BHARAT HEAVY ELECTRICALS LIMITED
PROJECT ENGINEERING MANAGEMENT, NOIDA

CORRIGENDUM- 08

PROJECT	:	NSPCL BHILAI EXPANSION POWER PROJECT(2X250MW) FGD
PACKAGE	:	GYPSUM DEWATERING SYSTEM
TENDER ENQUIRY NO	:	PE/PG/RGM/E-6513/2020 Dt. 02/09/2020
SUBJECT	:	REGARDING REPLY OF PRE BID QUERY

PRE BID CLARIFICATIONS - 1

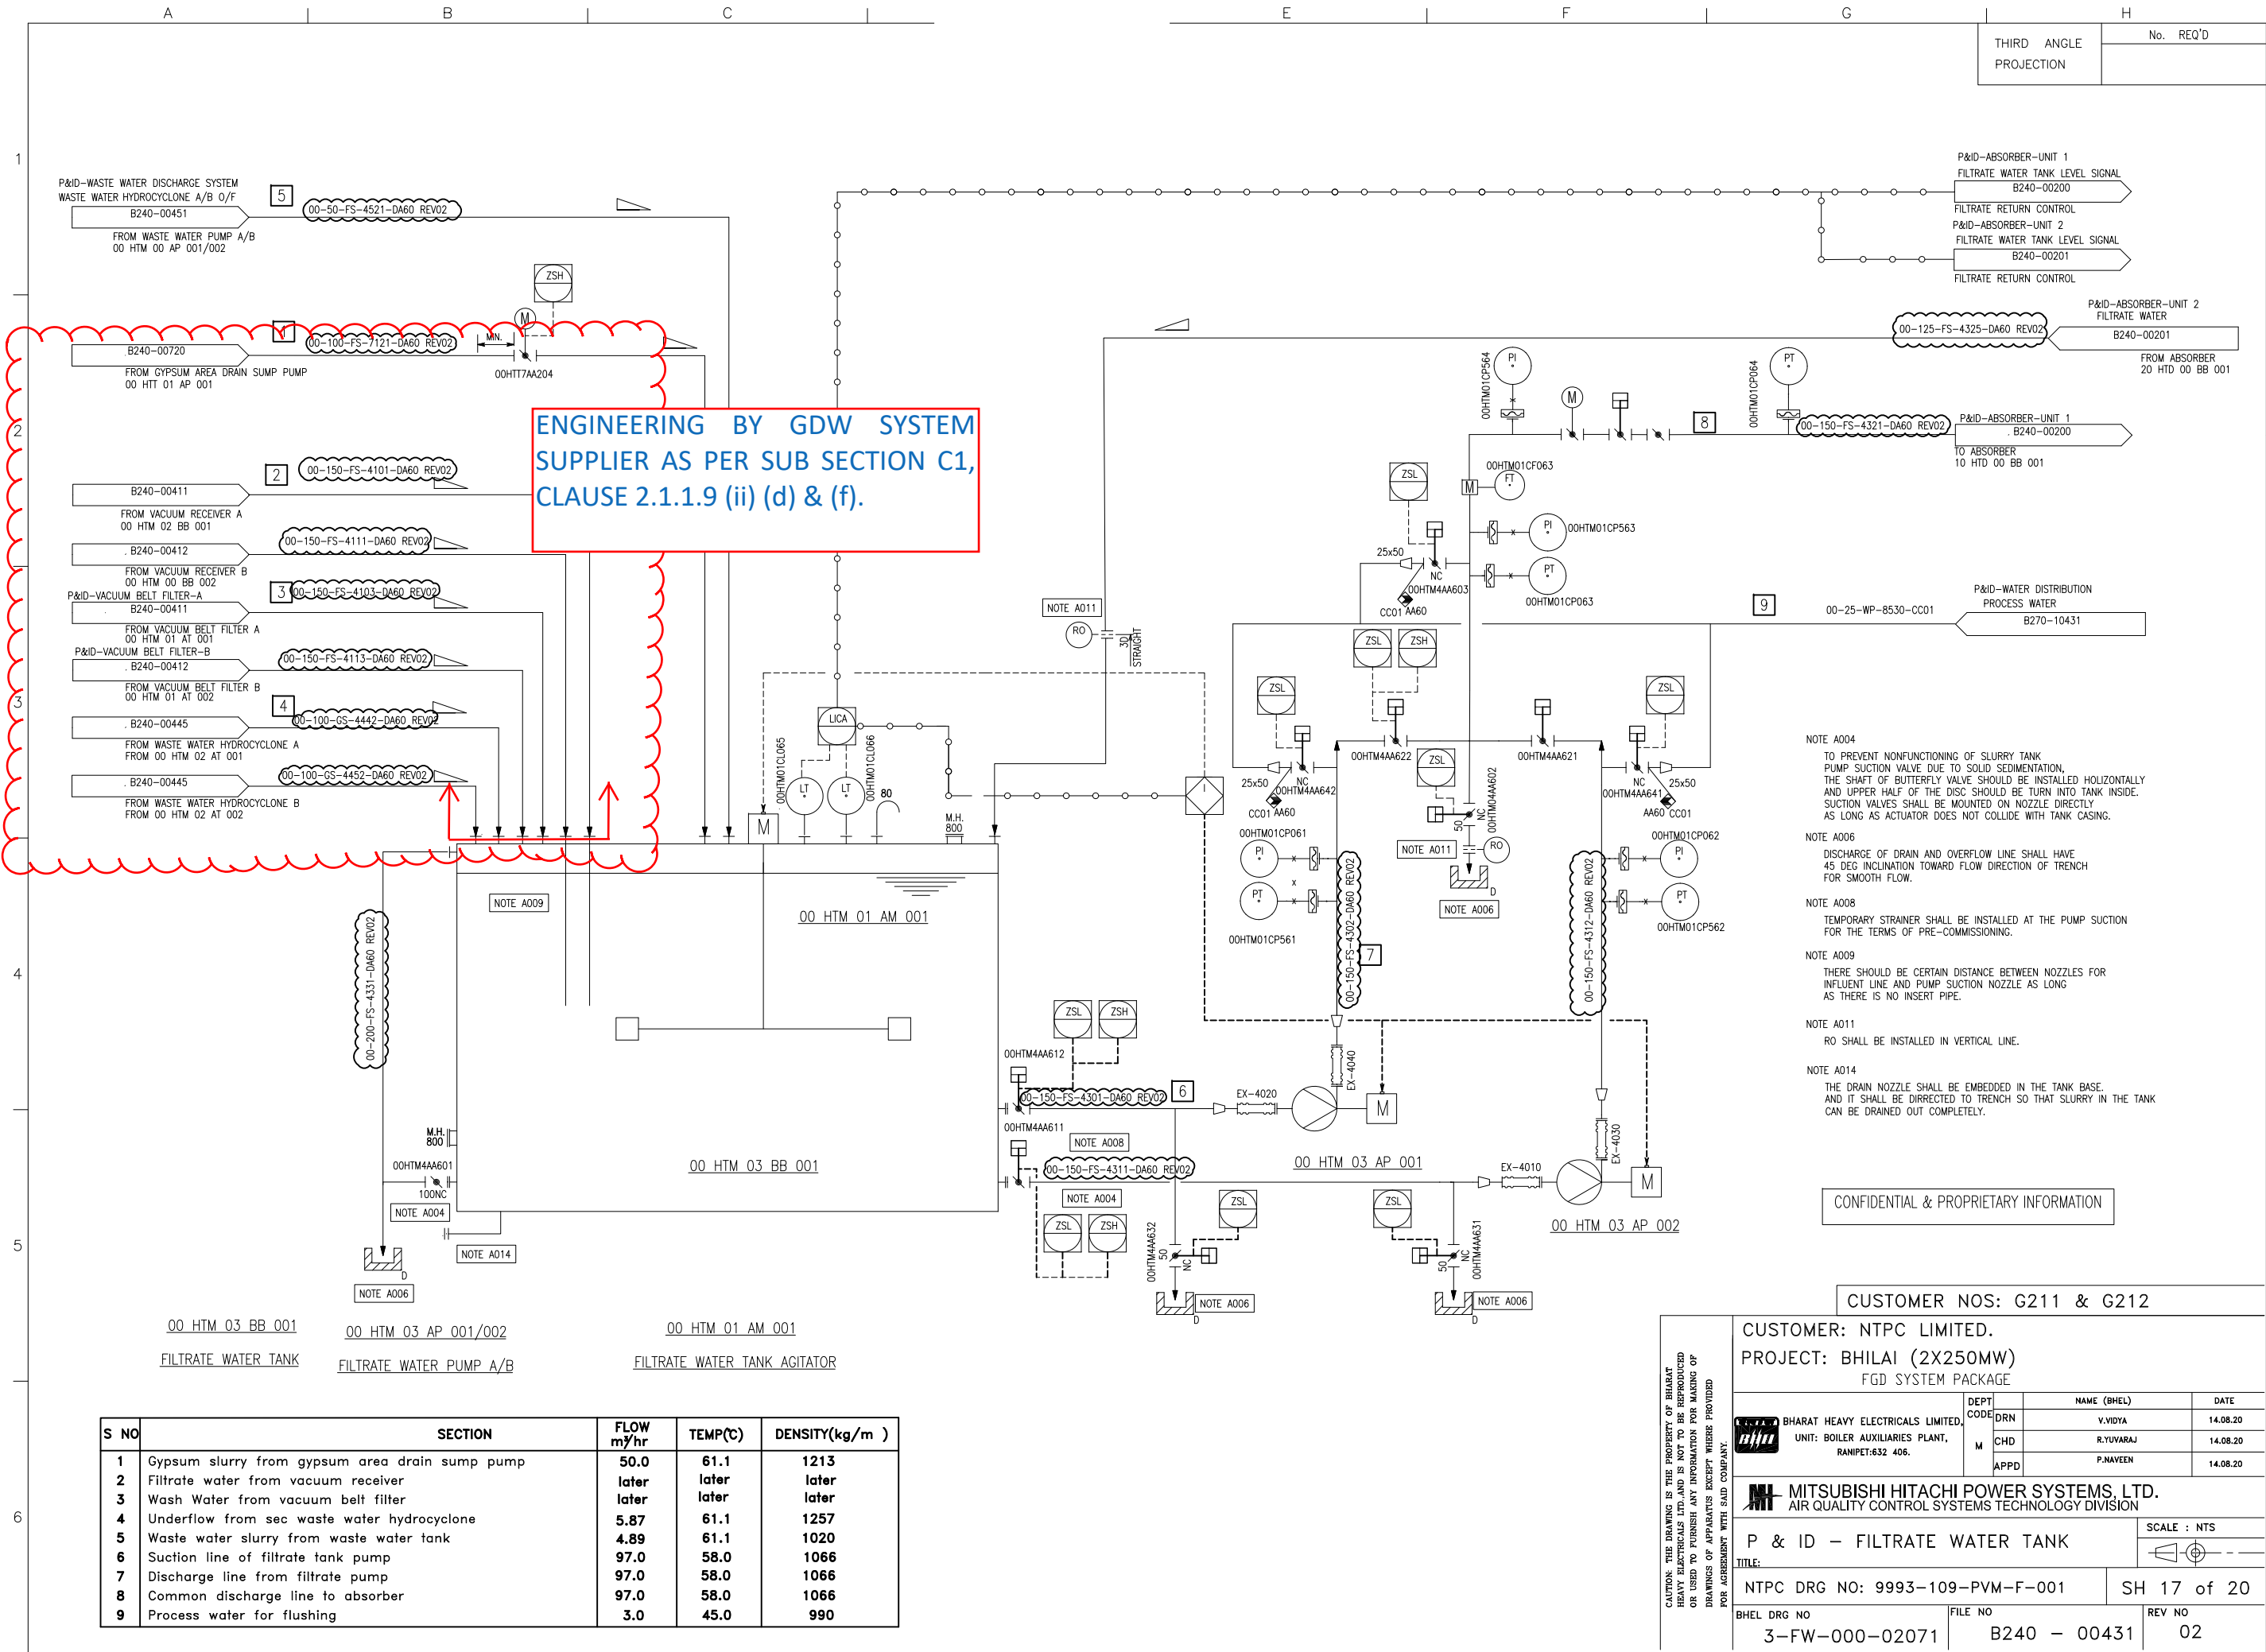
72			Gypsum Purity	Chemical composition of solids in feed slurry at hydro cyclone inlet is not provided. The main concern is about the impurities (like inerts & fly ash) content in hydro cyclone feed since high impurities content (>10%) hinders the dewatering process in VBF. Hence, the impurities content shall be restricted to max. 10%. Please provide feed slurry solids chemical composition.	Bidder to refer clause 1.2.4 Sub section C1, page 38 of 537, wherein it is mentioned that the Gypsum purity is in BHEL's scope. However, the moisture content (<10%) and chloride content (<100 ppm) in the output gypsum cake is to be guaranteed by the bidder at rated capacity. Feed slurry solids composition will be shared during detail engineering.
73					P&IDs for bidder's scope of Engineering as per Clause 2.1.1.9 (ii) (d), (e) & (f) are enclosed as Annexure-C to this pre-bid clarifications.

S NO	SECTION	FLOW m ³ /hr	TEMP(°C)	DENSITY(kg/m ³)
1	Gypsum slurry from gypsum area drain sump pump	50.0	61.1	1213
2	Filtrate water from vacuum receiver	later	later	later
3	Wash Water from vacuum belt filter	later	later	later
4	Underflow from sec waste water hydrocyclone	5.87	61.1	1257
5	Waste water slurry from waste water tank	4.89	61.1	1020
6	Suction line of filtrate tank pump	97.0	58.0	1066
7	Discharge line from filtrate pump	97.0	58.0	1066
8	Common discharge line to absorber	97.0	58.0	1066
9	Process water for flushing	3.0	45.0	990
